B Service Bulletin

BULLETIN NO: DM 441B-14
DME Interrogator

To improve receiver sensitivity at 113.80 MHz.

Figure 1
DM 441B Receiver
-00 through -11 versions

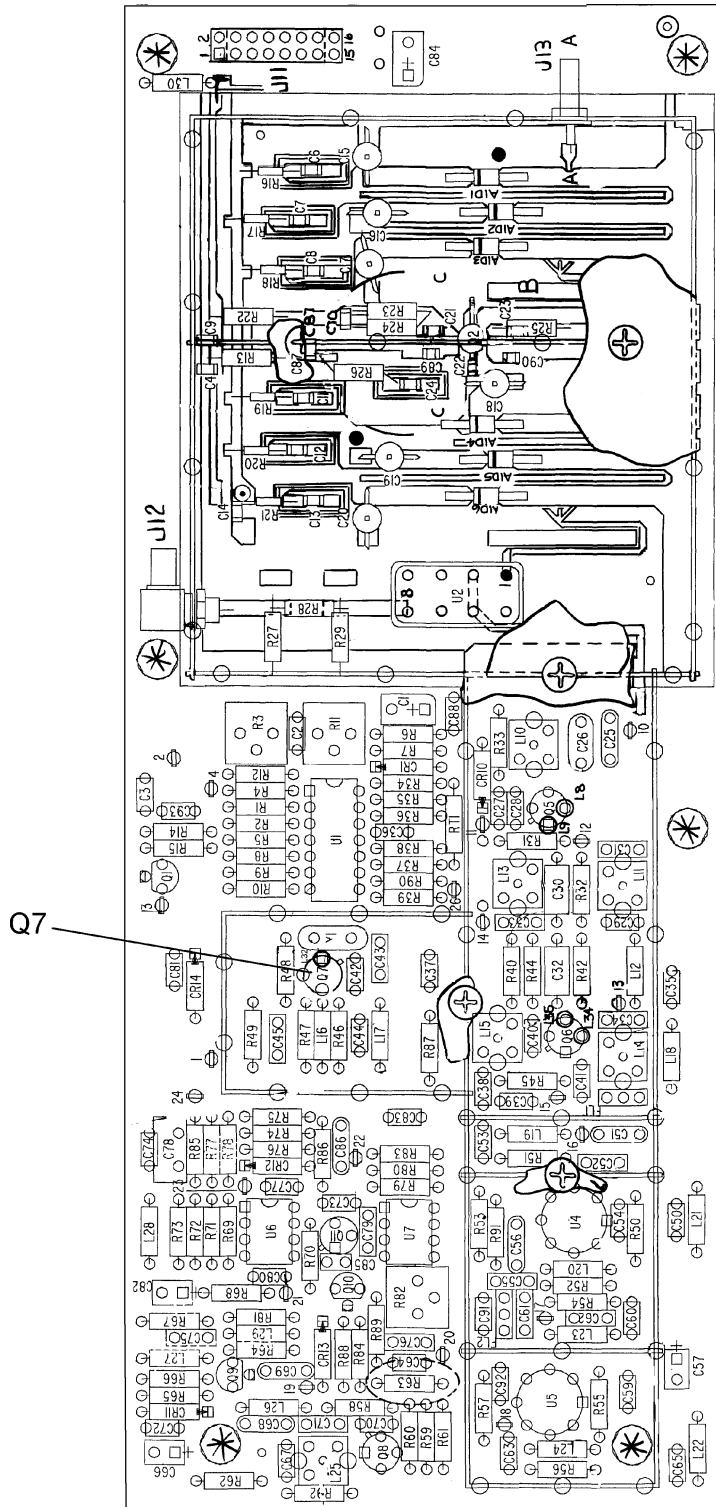
1. Access the Receiver Module per the disassembly procedures in the DM 441B Section of the Maintenance Manual.
2. See Figure 1. Remove Q7. Discard L31 and L33. Transfer L32 to the corresponding lead of the new Q7. Install the new transistor Q7, P/N 007-00383-0050.
3. Reassemble the unit by reversing the disassembly procedures.
